Technical Service Bulletin: tsb100944

New Oil Suction Tube and Brackets

This Technical Service Bulletin introduces a new lubricating oil suction tube and brackets for QST30 rear deep sump applications; Option OP 5137 **only**. The new oil suction tube and brackets have been designed to reduce cracking in the oil suction tube, caused by vibration.

Figure 1: Bottom View - New Suction Tube (1) vs. Old Suction Tube (2)

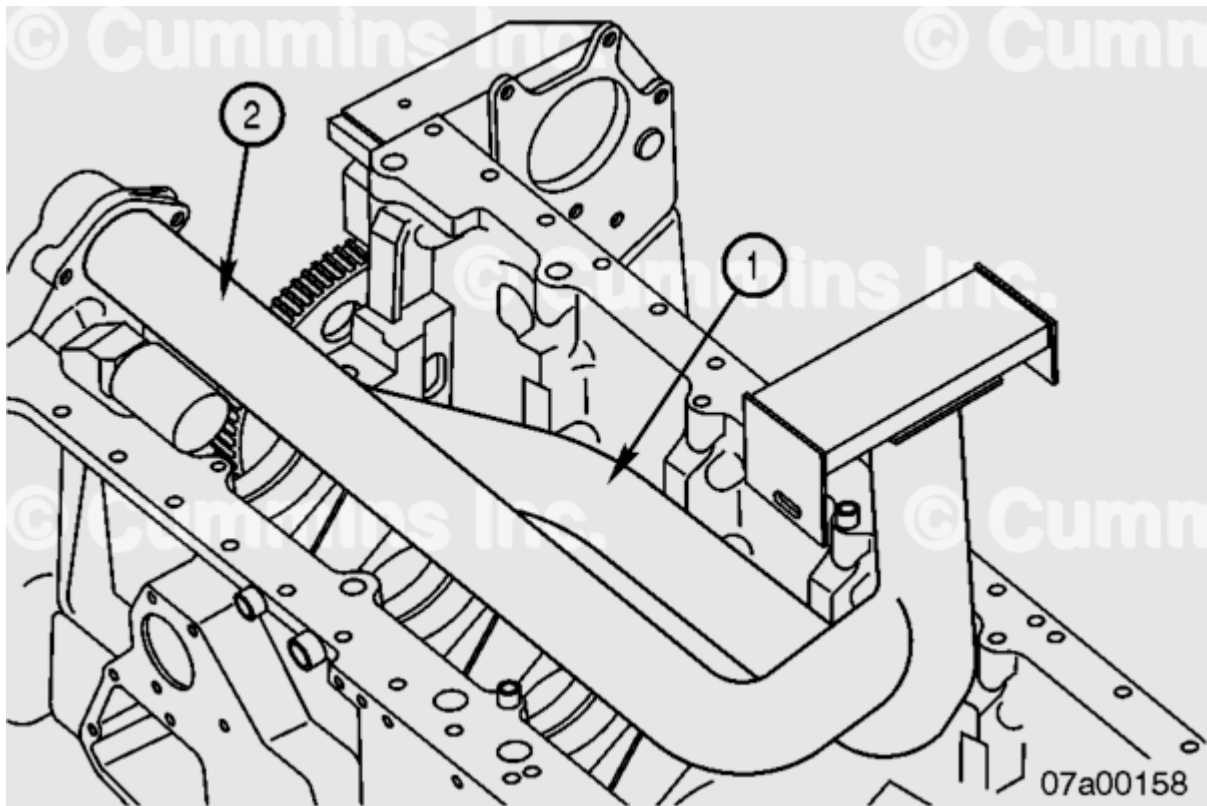
The new tube can be identified by the bend in the horizontal portion of the suction tube. Compared to the new tube, the old tube is straighter, as illustrated in Figure 1. The new bracket design has been changed from a side-mount design, as illustrated in Figure 2, to a center-mount design, as illustrated in Figure 3.

The new oil suction tube, Part Number 4975629, obsoletes and supersedes the old oil suction tube, Part Number 3092243. The new bracket, Part Number 4975644, and two clamps, Part Number 4975653, obsolete and supersede the old bracket, Part Number 3092242. Reference the table below for old and new part numbers within Option OP 5137.
